PLANNING DIRECTOR'S SPECIAL PERMIT
FOR SINGLE FAMILY RESIDENTIAL IN A PUD

FILE: P02-070

PROJECT NAME: Heritage Park - Lennar Renaissance - 55' wide lots

RE: Design Review of Renaissance Homes Plans – Heritage Park

Exhibit 3b:
Plan 5 Elevations

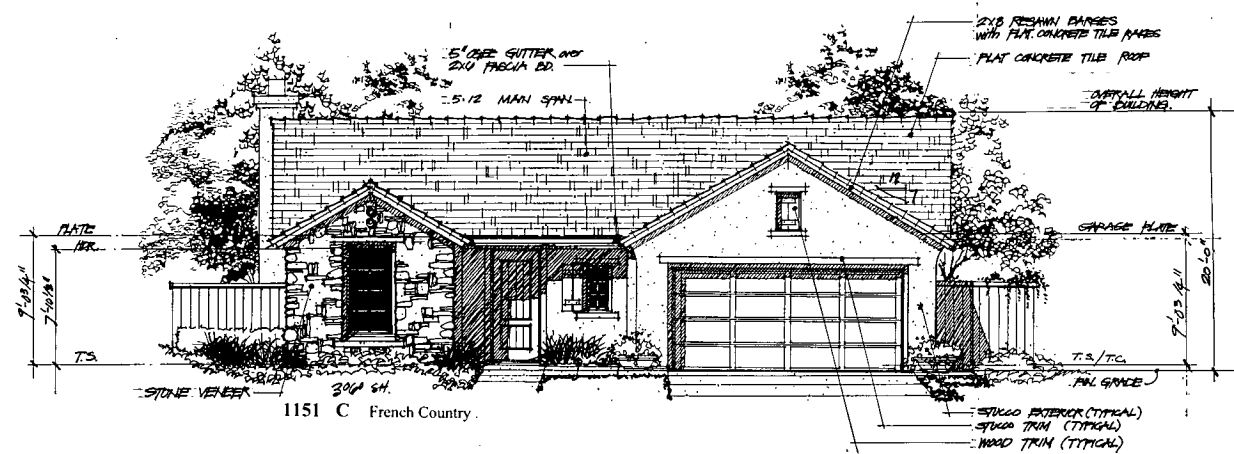
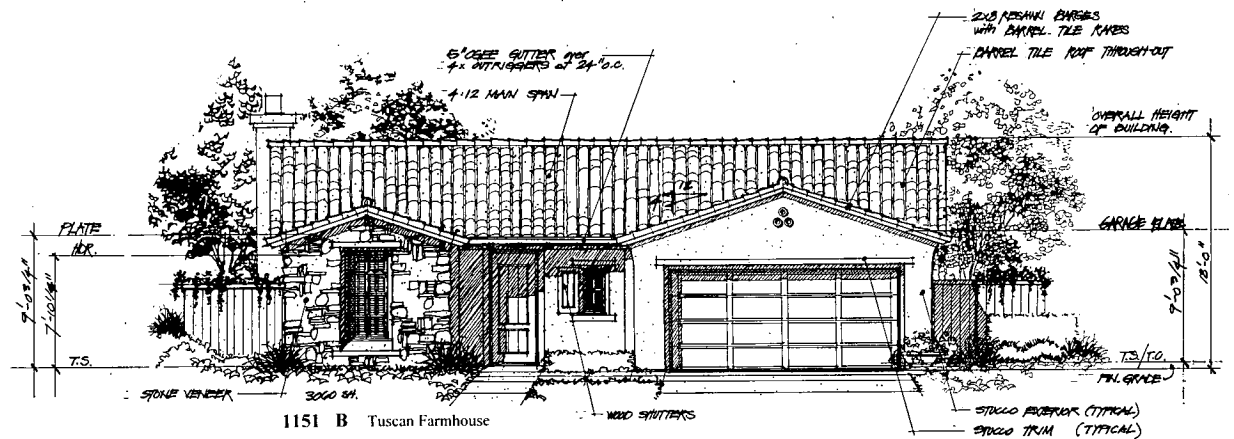
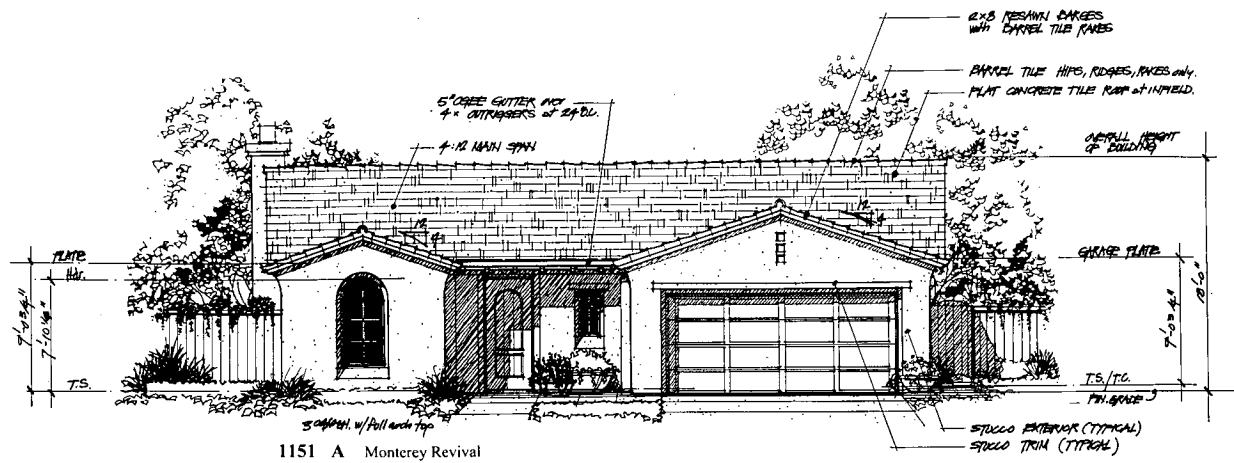
1. Homes with back or sides to streets, parks, open space and schools need to continue trim along visible side of house, as noted on plans.
2. Materials shall wrap on the sides of the homes, as noted on the plans.
3. The accent materials shown on plans are to be standard materials, not options.
4. Driveways shall have a pattern of score lines that will create a pleasing texture compatible with the architecture.
